SERVICE BULLETIN

APPLICABILITY: 2014-19MY Crosstrek
 2014-19MY Forester
 2014-19MY Impreza
 2014MY WRX

NUMBER: 05-76-20
DATE: 08/31/20

SUBJECT: Front Wheel Hub Assembly- Design Change

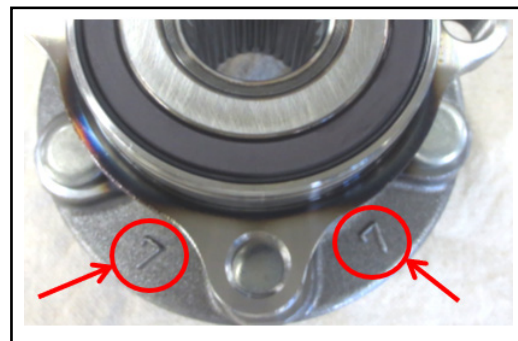
This bulletin announces availability of new front wheel hub assemblies incorporating bearing surfaces having increased resistance to imperfections resulting from shock loads. Excessive shock loads can occur when hitting a significant imperfection in the road surface (e.g. large pothole or expansion joint). If the bearing surface is affected, a growling -type sound may become audible when vehicle speed exceeds 25 MPH.

NOTE: The new part can be easily identified by “7”s made onto the back of the flange as shown here.

Description	Part Number	Application
HUB COMPLETE- FRONT AXLE	28373FL010	SBR (Japan) Built Models
	28373FL00C	SIA (U.S.) Built Models
	28373FL01A	Built Models
